CHANGE ORDER REQUEST

PROJECT NAME: Barth Athletics Complex
HMS Phase IIIA

SCMC C.O.R. #: 7
DATE: 5/8/2019

Furnish and install wall angle duct supports
Per RFI # 07 response

M2.02

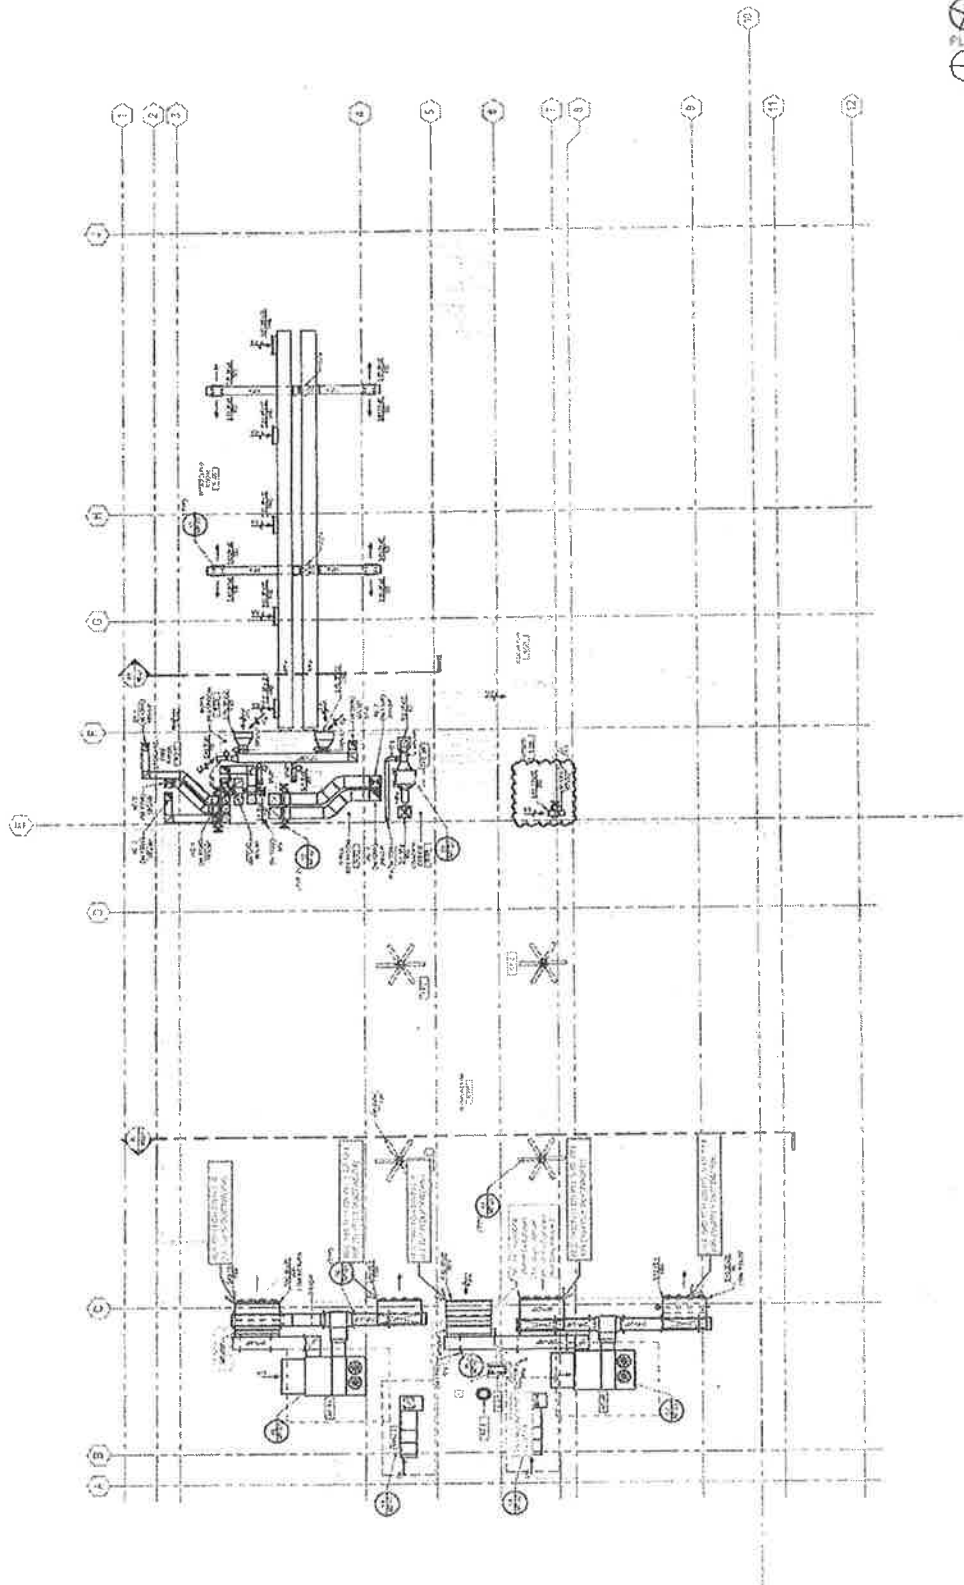
Refer to M2.02 and 2/A3.11 attached

There are two 90x30 (L) return duct branches extending from 28x46 (L) return plenums from units AC-4A & 4B.

The main 28x46 plenum ducts are shown with duct supports either side of branch connections per 09/M7.01 but there are no support shown under 90x30 branch ductwork.

90x30 return ducts extend approx. 5'-0" from gymnasium wall penetration at C-column line.

Do these 90x30 return ducts require supports?

Special Note: duct support detail 09/M7.01 shows maximum duct size as 28w x 48h

Add 45's to bring supply duct close to wall per RFI #06. For return ductwork, please see attached sketch (page 4) detailing attachment from duct to exterior wall. No additional duct supports required.
